Hi-Fi Products
Service Bulletin

Model: CDP-510/910/505ESD

No. 25

Subject: Intermittent No Eject

Note: Diagram shown is for the CDP-510.

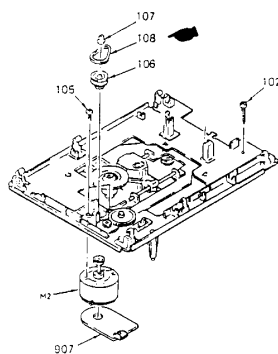
Loading tray is intermittently not ejected.

Solution: Replace the driving belt with the new one as shown:

Model	Ref. No.	Description	Part Number	
			Former	New
CDP-510	108	Driving Belt	4-917-548-01	4-917-548-02
CDP-910	206	Driving Belt	4-917-548-01	4-917-548-02
CDP-505ESD	206	Driving Belt	4-917-548-01	4-917-548-02
